**World Forum for Harmonization of Vehicle Regulations****Working Party on Passive Safety****Fifty-seventh session**

**Collective amendments to Regulations Nos. 14 and 16****Proposal for Supplement 7 to the 06 series of amendments to Regulation No. 14 and Supplement 6 to the 06 series of amendments to Regulation No. 16****Submitted by the expert from the Netherlands\***

The text reproduced below was prepared by the experts from the Netherlands to clarify height requirements for the effective upper belt anchorage introduced by the Supplement 4 to the 07 series of amendments to Regulation No. 14. This text is based on informal document GRSP-56-19 distributed during the fifty-sixth session of the Working Party on Passive Safety (GRSP). The modifications to the current text of the UN Regulations Nos. 14 and 16 are marked in bold for new or strikethrough for deleted characters.

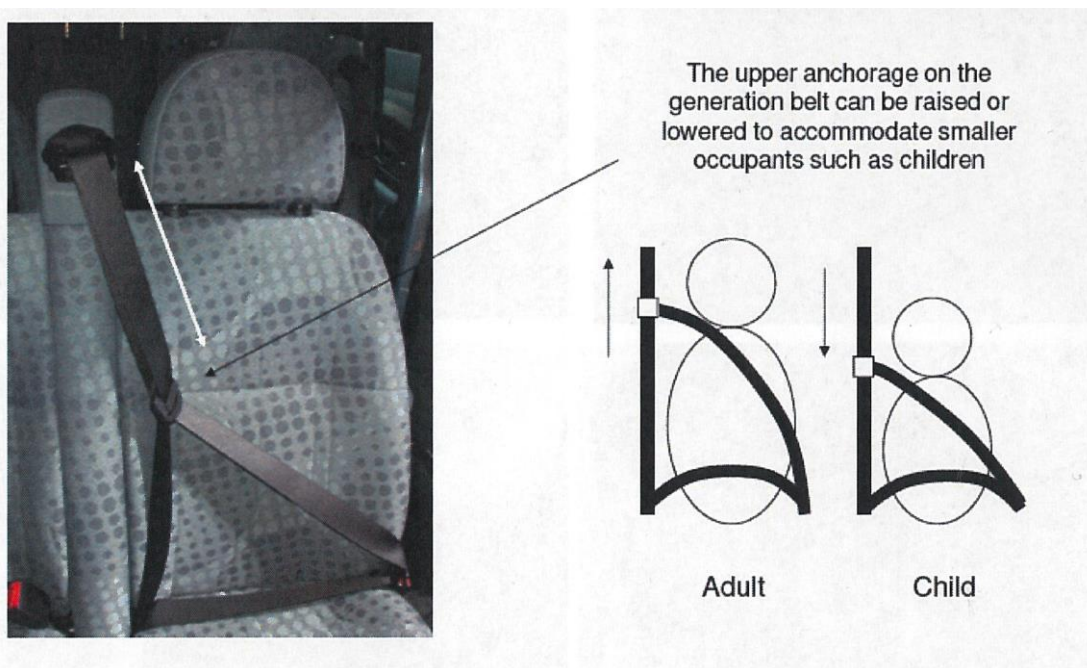
2. The situation explained above has caused confusion so far: a belt/restraint system that makes use of a **flexible shoulder adjustment device for height** (sometimes called **generation belt**, see the explaining figure on next page), does not make use of the upper-pillar loop for adjustment and therefore cannot be mentioned on the Communication form.

3. Accordingly, authorities (responsible for the installation approval of a belt in a vehicle (Communication sheet 1A)) did not always react, by means of the Regulation No. 16 (Annex 1B) to a restraint system concerning a belt system with a flexible shoulder adjustment device for height! Note that this kind of belt system could have a location of the effective upper anchorage lower than the limit of 450 mm above the R-point, only in the case of installation on M<sub>2</sub> and M<sub>3</sub> vehicles (this is stated up to now only in UN Regulation No. 14 because the focus was merely on adjustable upper-pillar loops)!

4. This proposal introduces a definition for flexible shoulder adjustment device for height the situation will be clarified.
